## ADDENDUM No. 3

### RFP No. 25-53

#### LIBERTY STREET CREEK RESTORATION

Plant Schedule - Liberty Street Creek Restoration

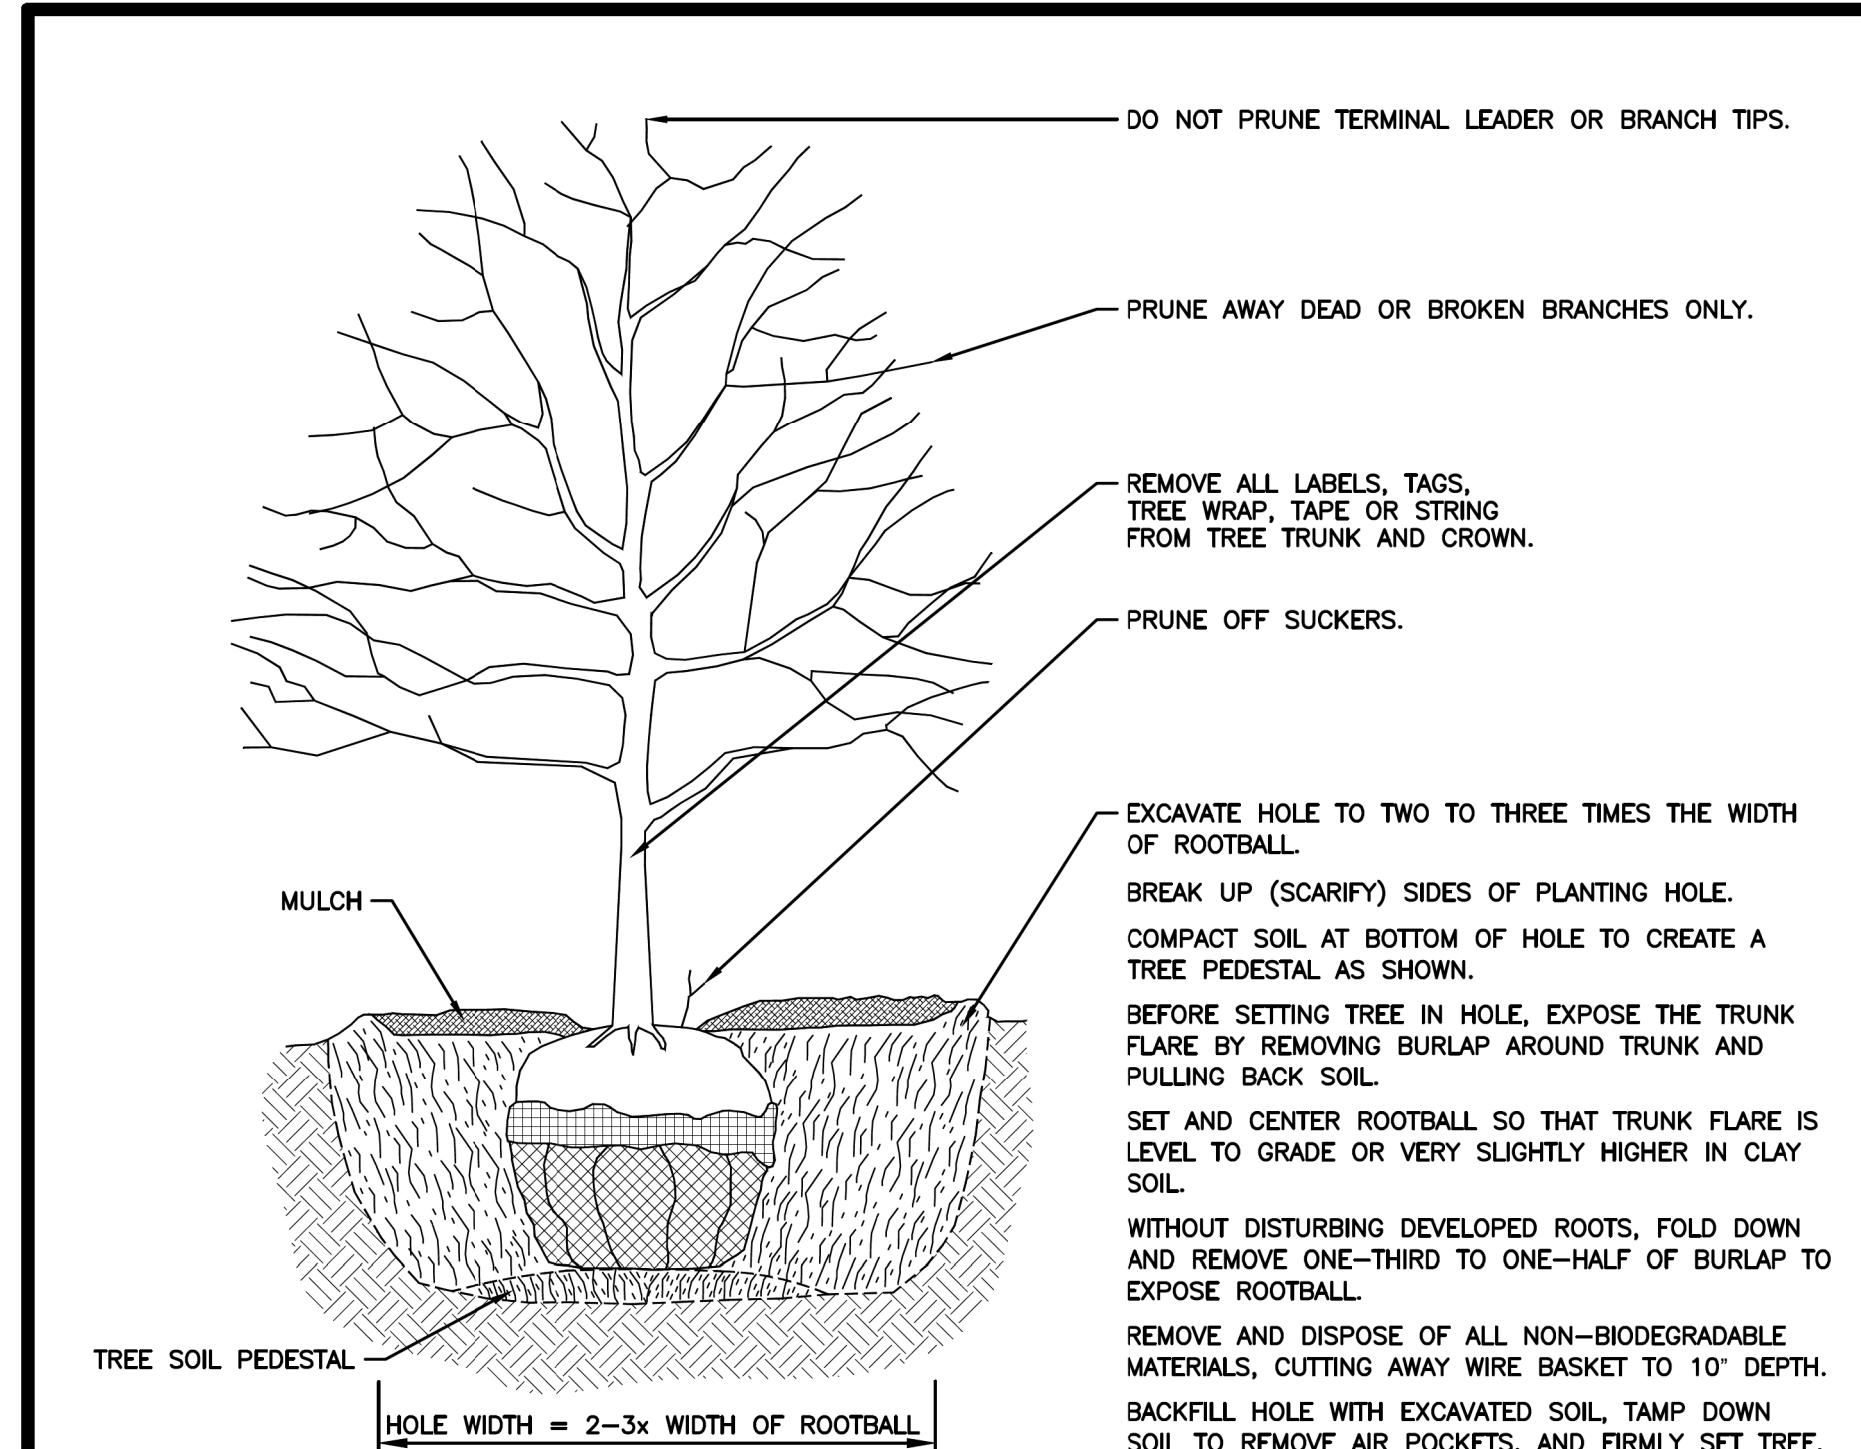
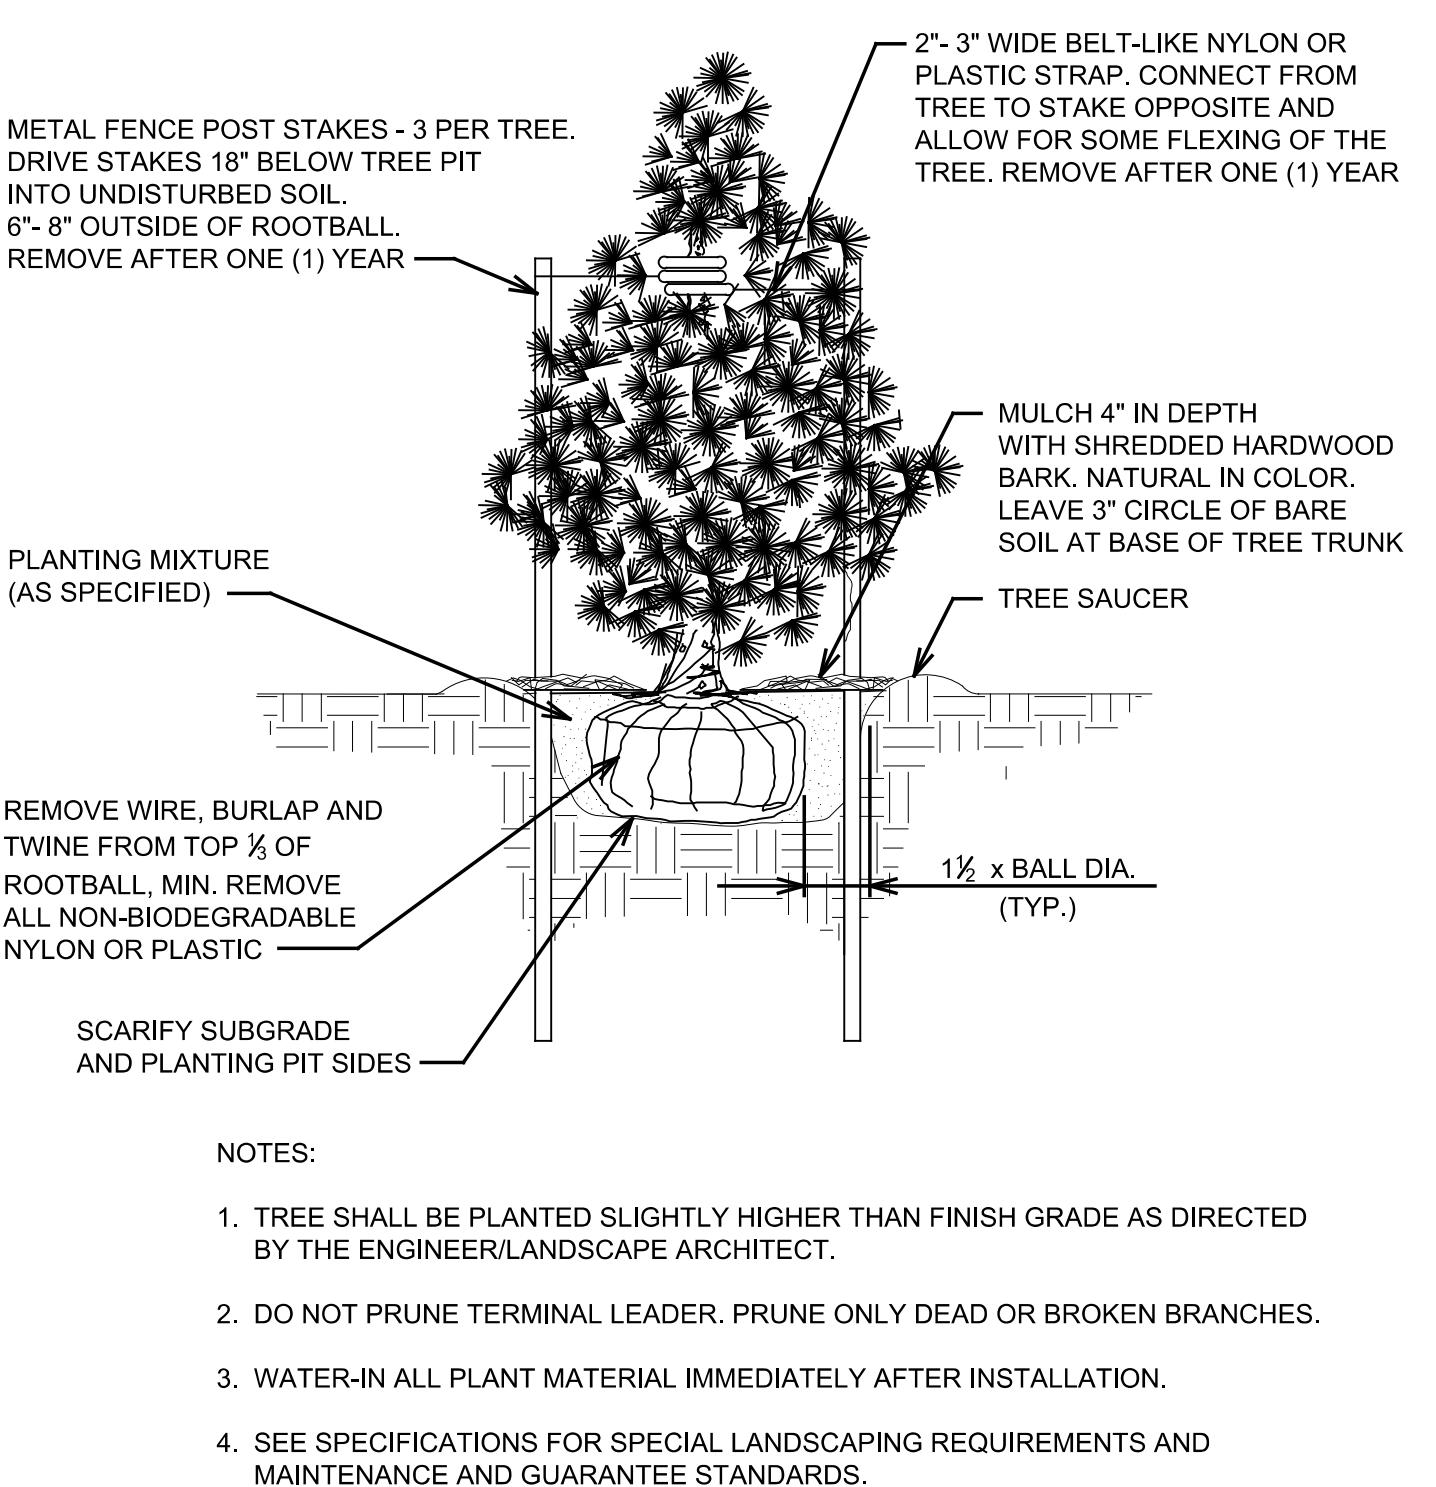
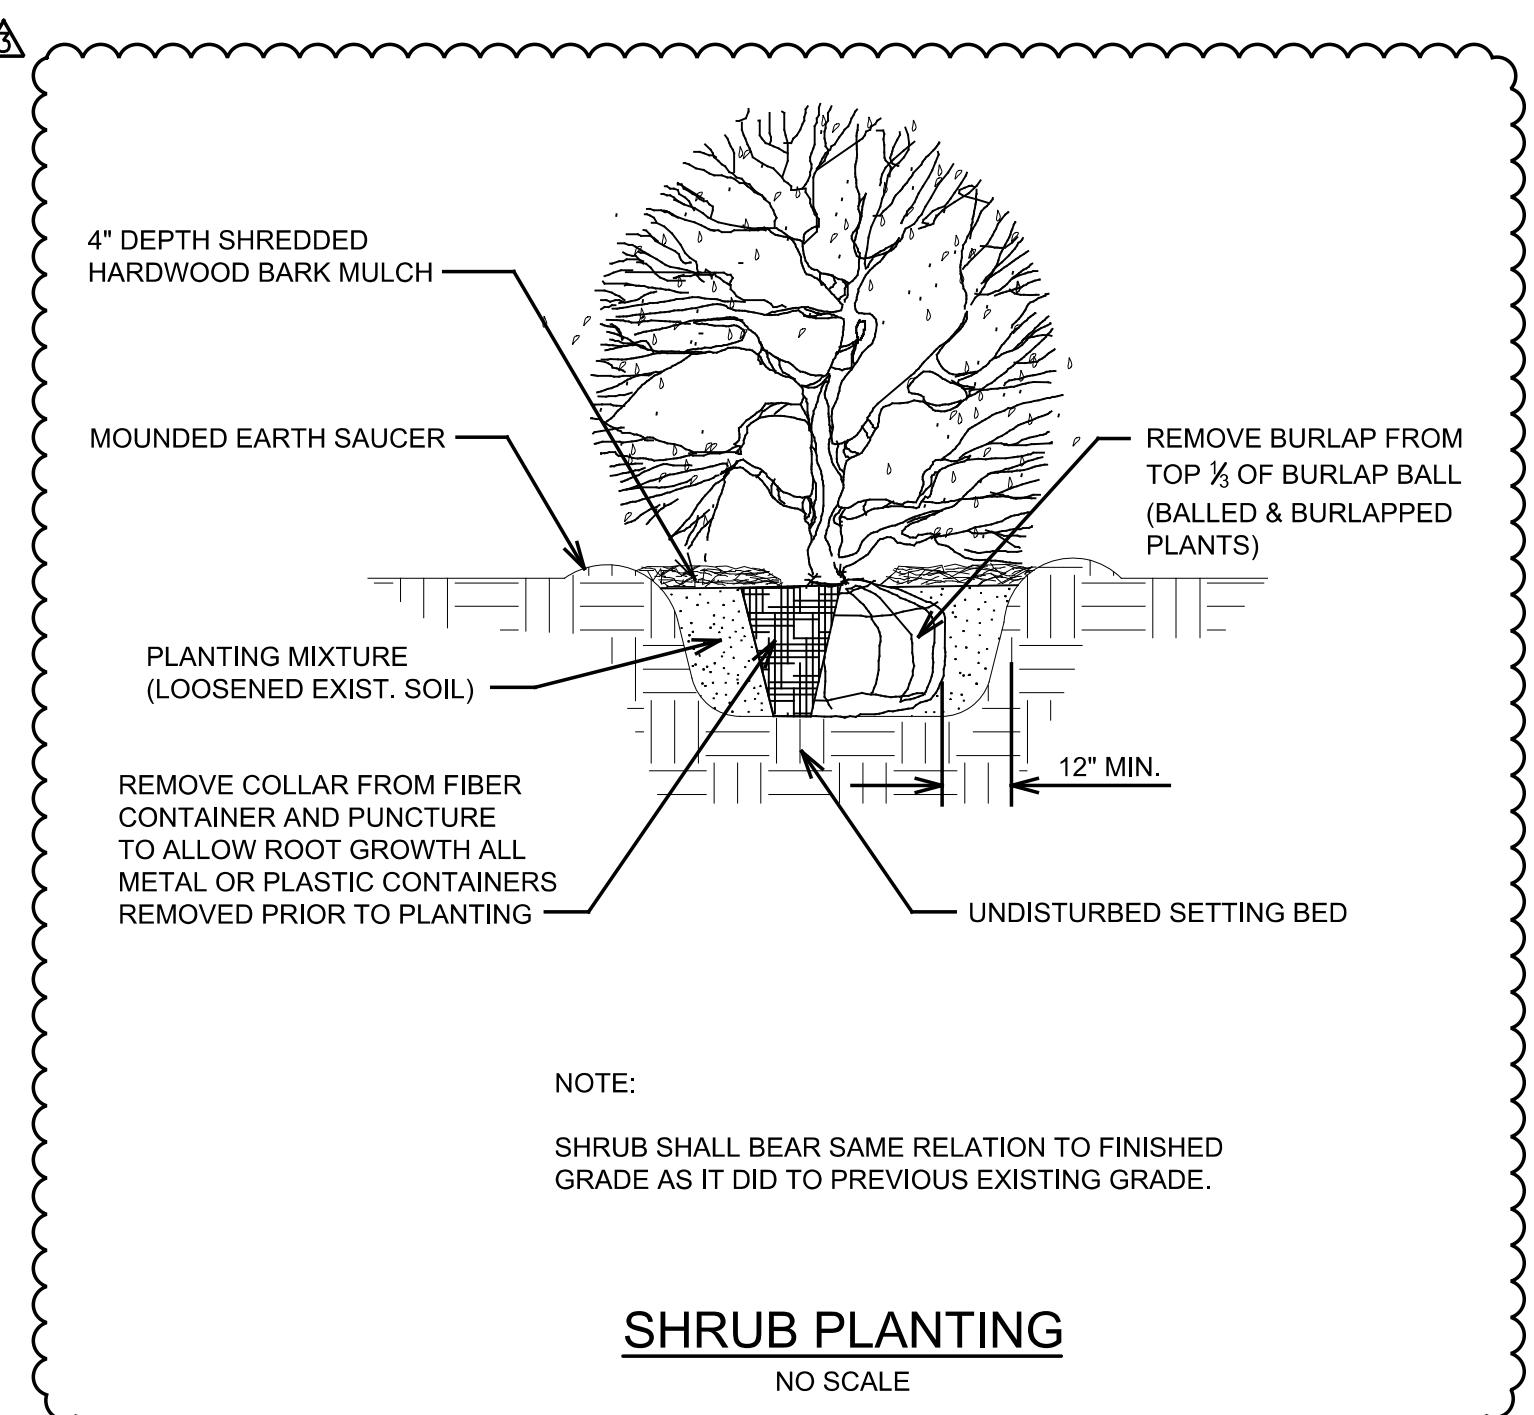
Sheet 22 – Project Details:

- Added Shrub Planting detail
- Added Plant Schedule for quantities.
- Added note to provide and include fencing as necessary to protect plantings.
